## Change Cover letter

15-LED50T-XXB

15-LED50T-XXD

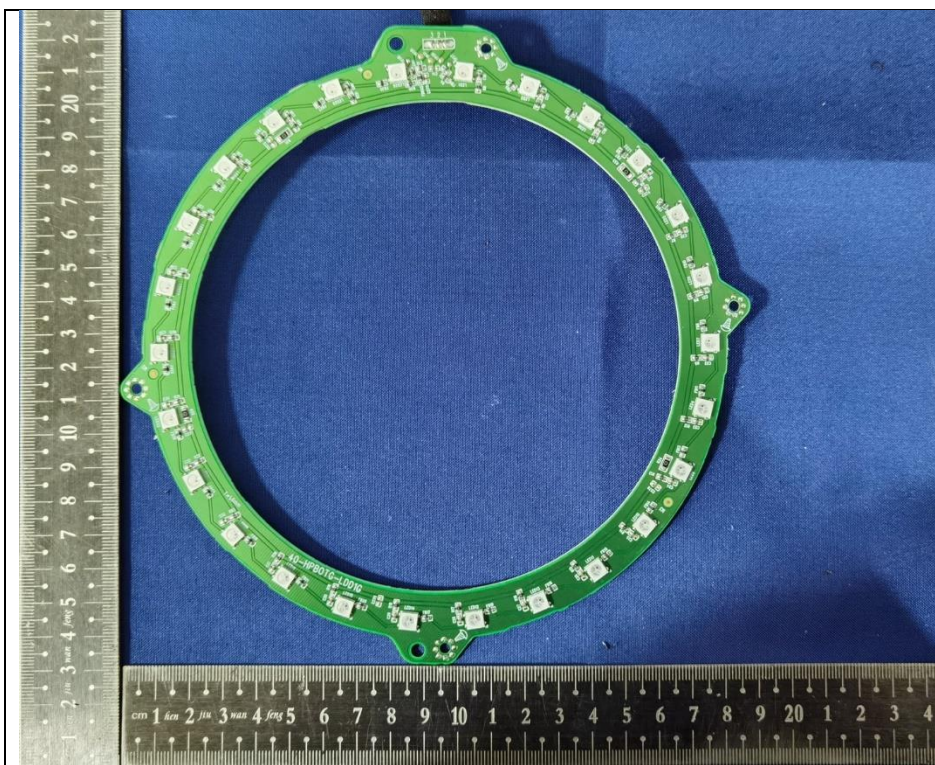
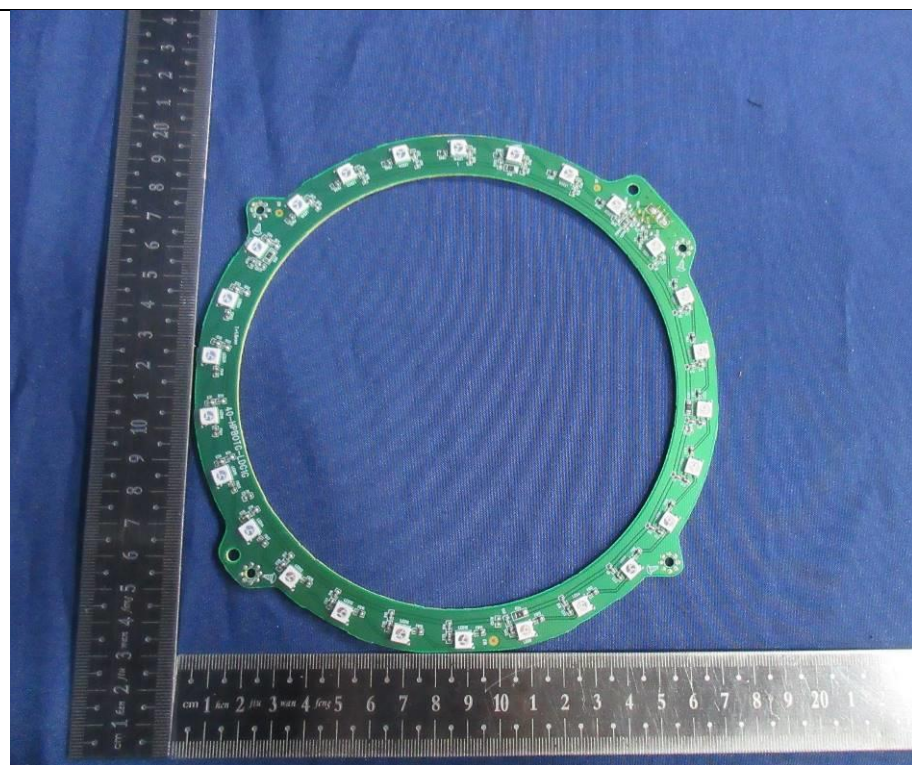
- 1 Cell change, The specifications and parameters are the same.
- 2 RGB light, The baking time is shortened from 24H to 6H.
- 3 change the microphone PCB, RF antenna receiving loop, copper air avoidance area in the ground plane of TOP layer is enlarged to improve receiving distance
